Site Instruction

SI 09

PROJECT : Hampton Manor
PROJECT No : 1136.13
DATE : December 7, 2017

Title: Added Pipe space in garbage intake room

2ND FLOOR ENLARGED
PART PLAN

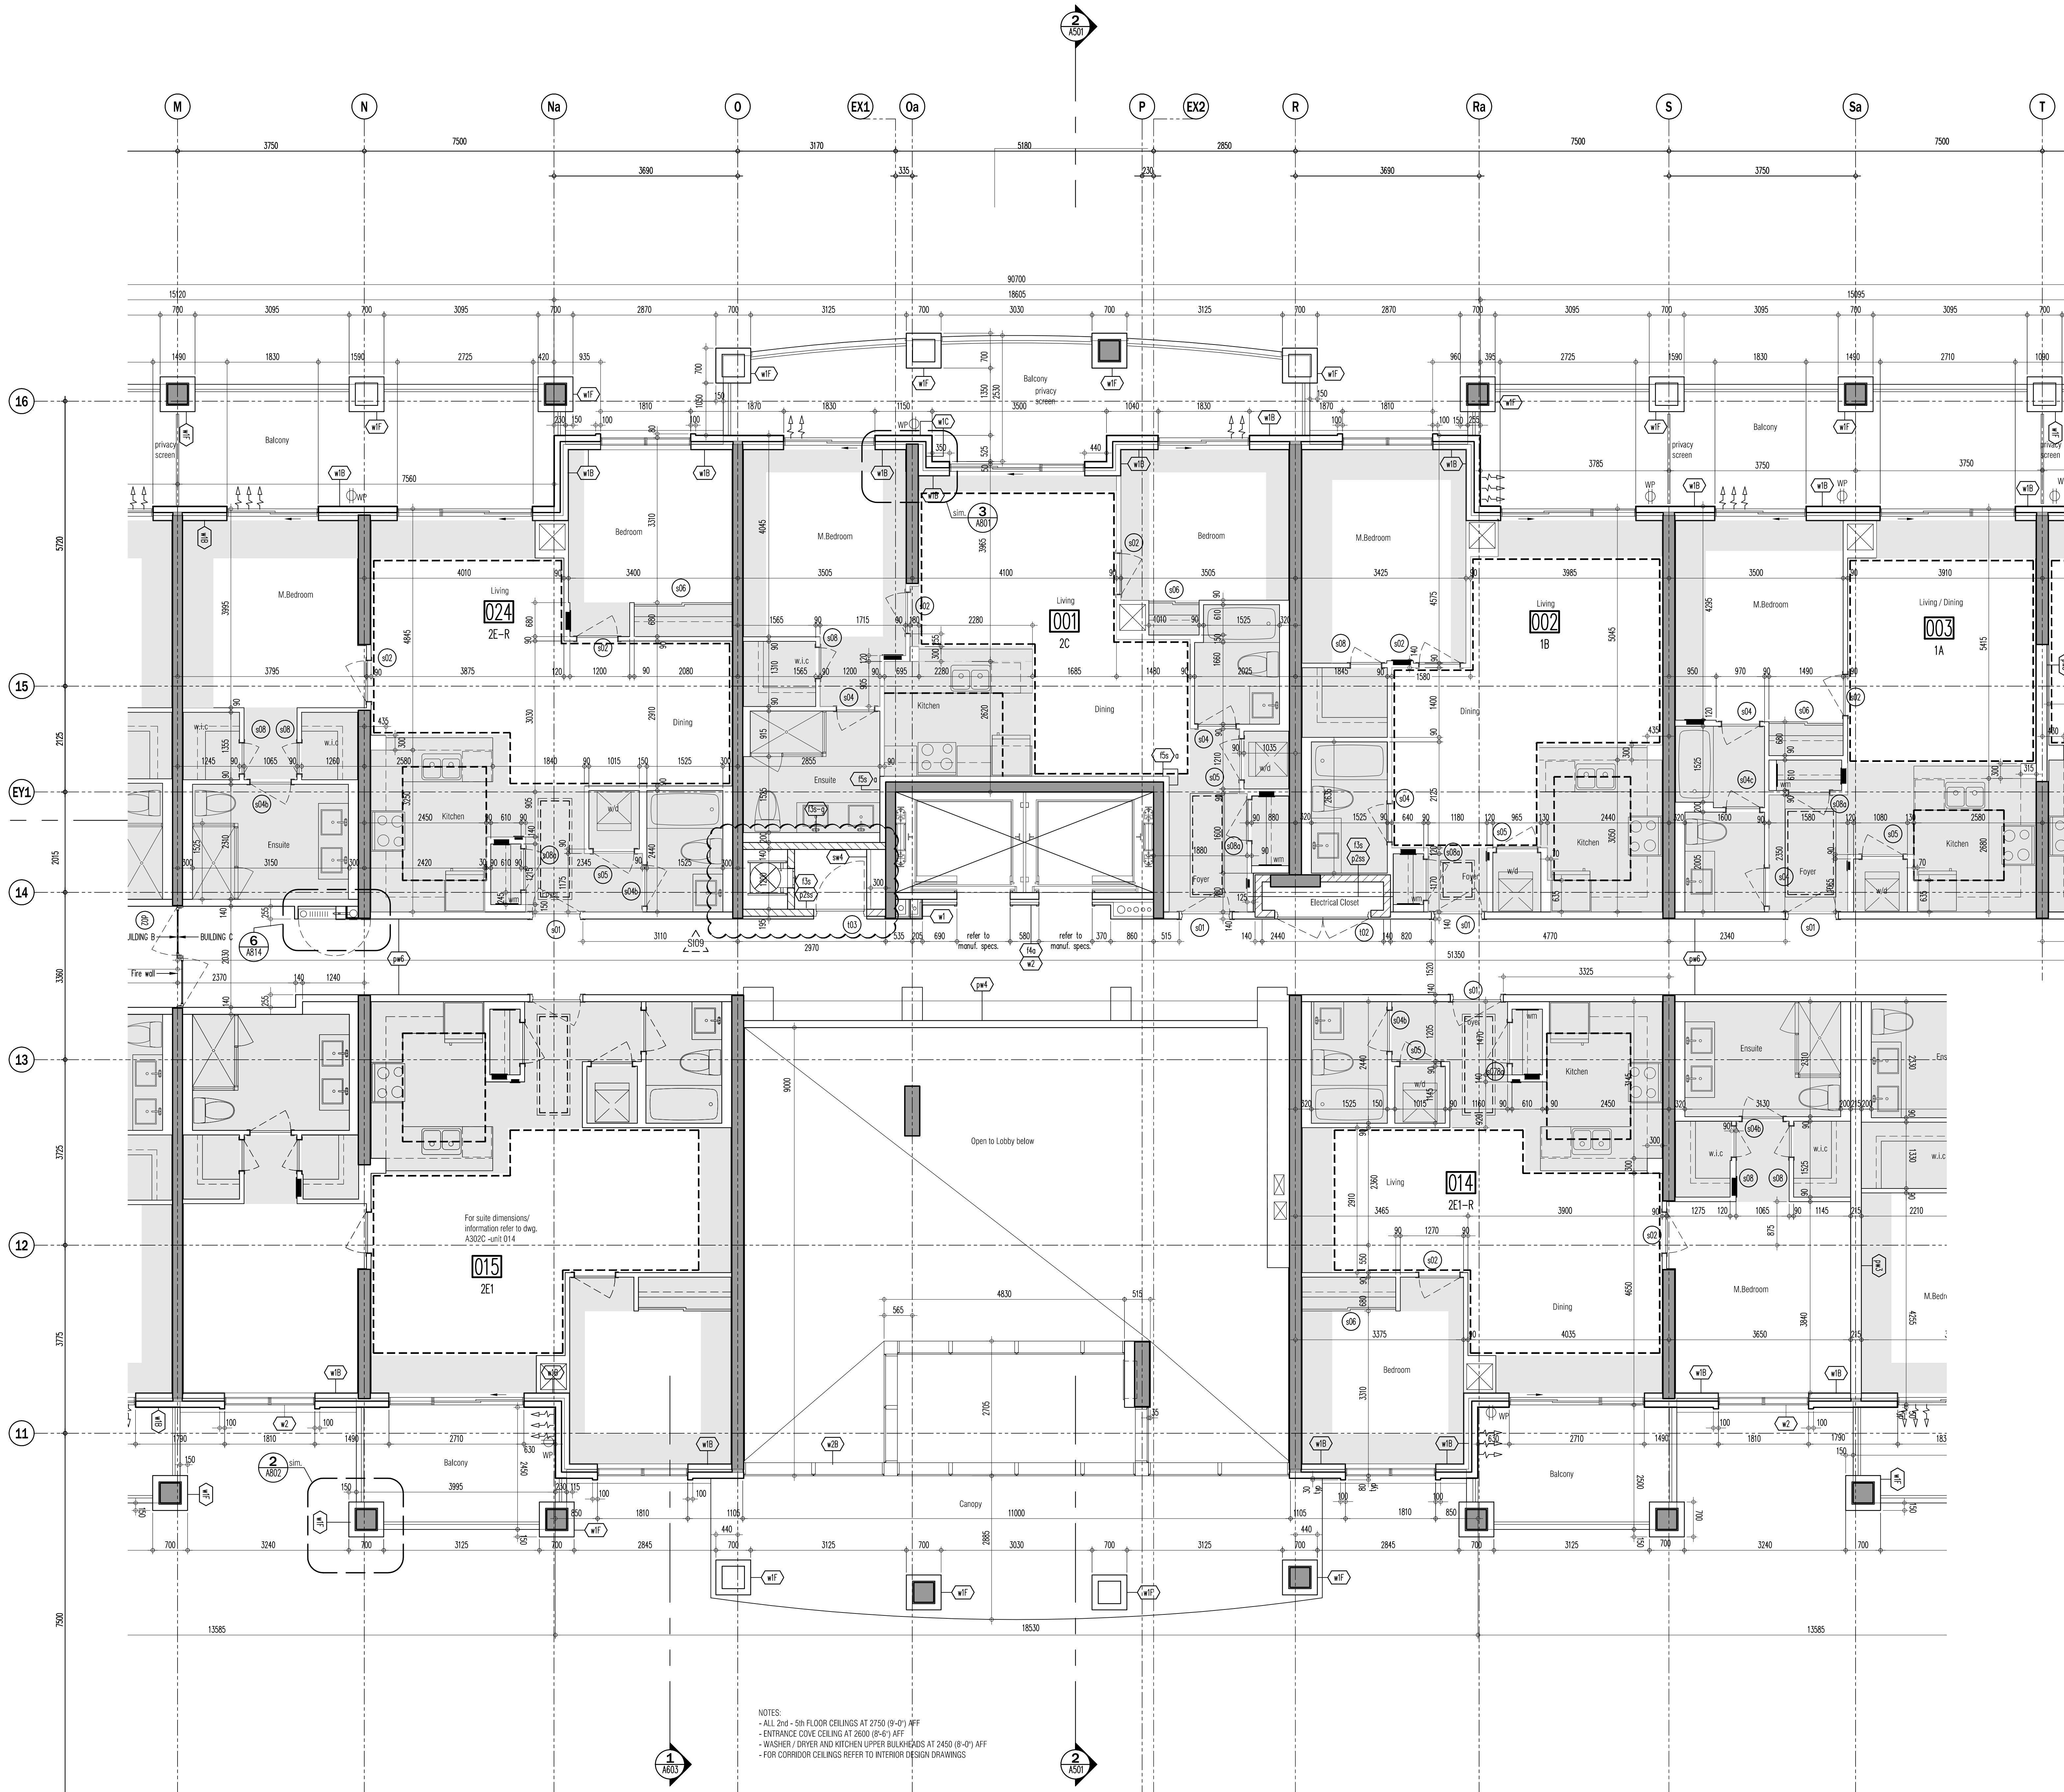
- Adding pipe space to garbage intake room.

6TH FLOOR PLAN

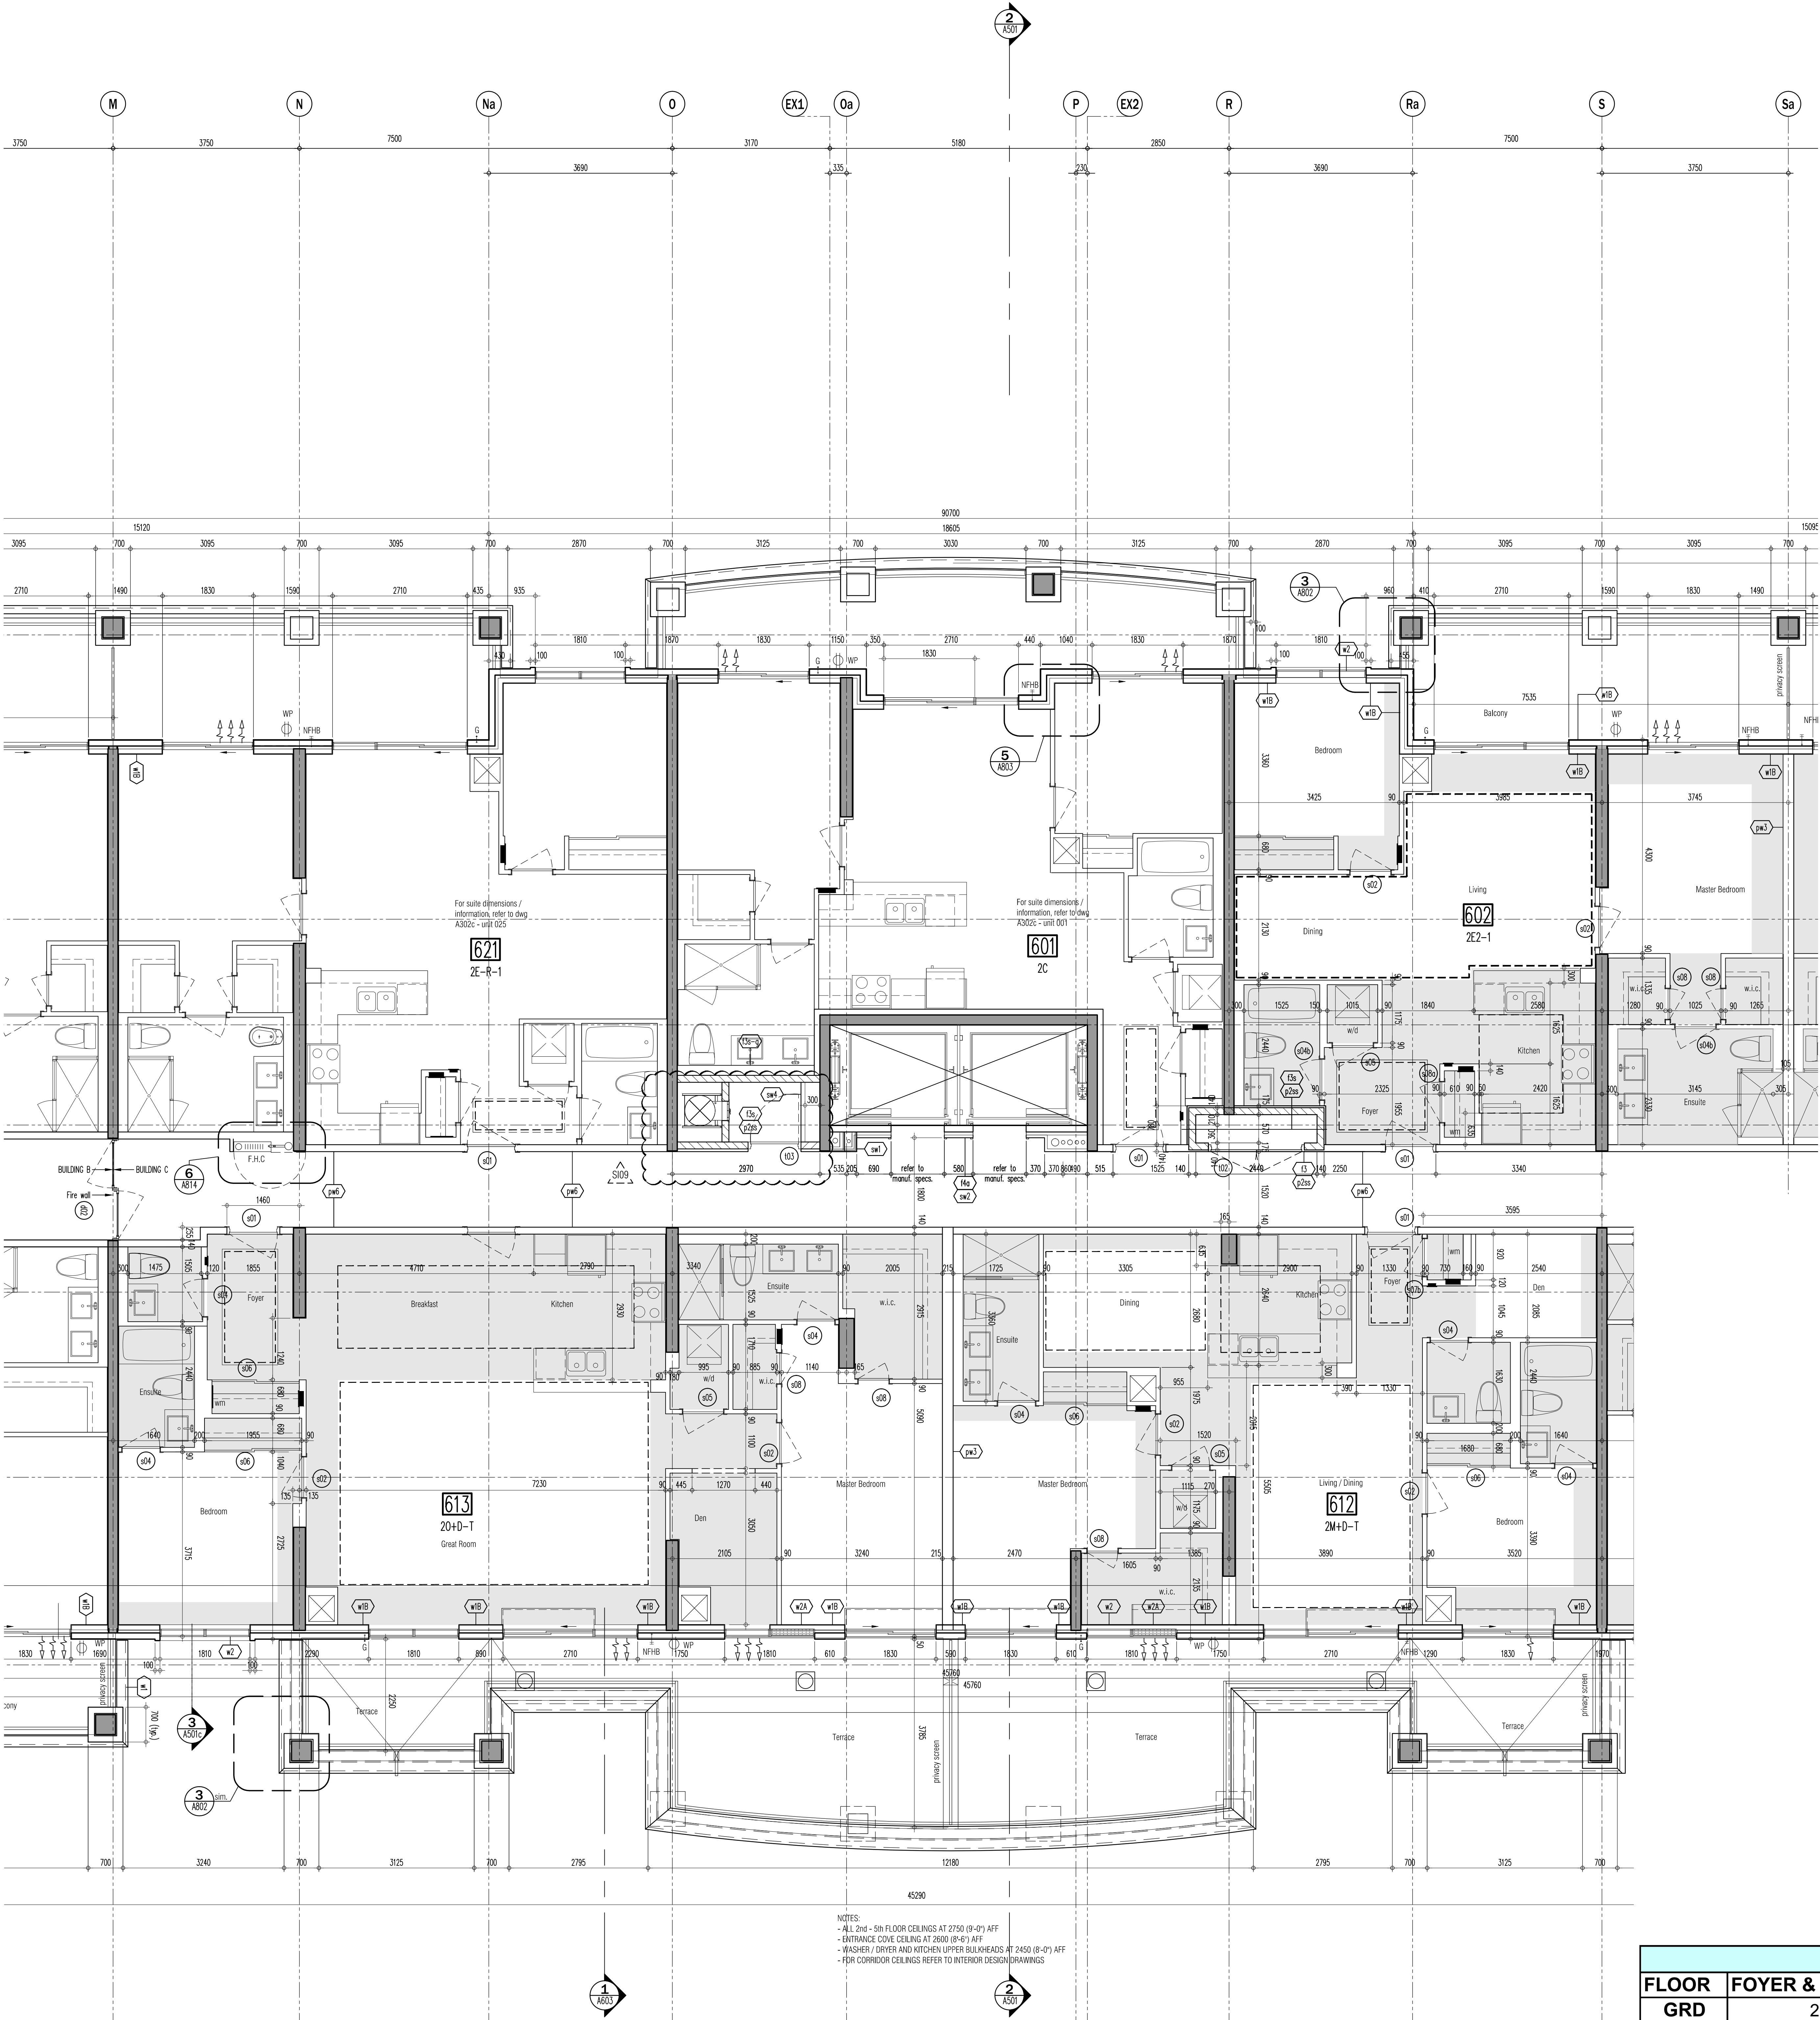
- Adding pipe space to garbage intake room.
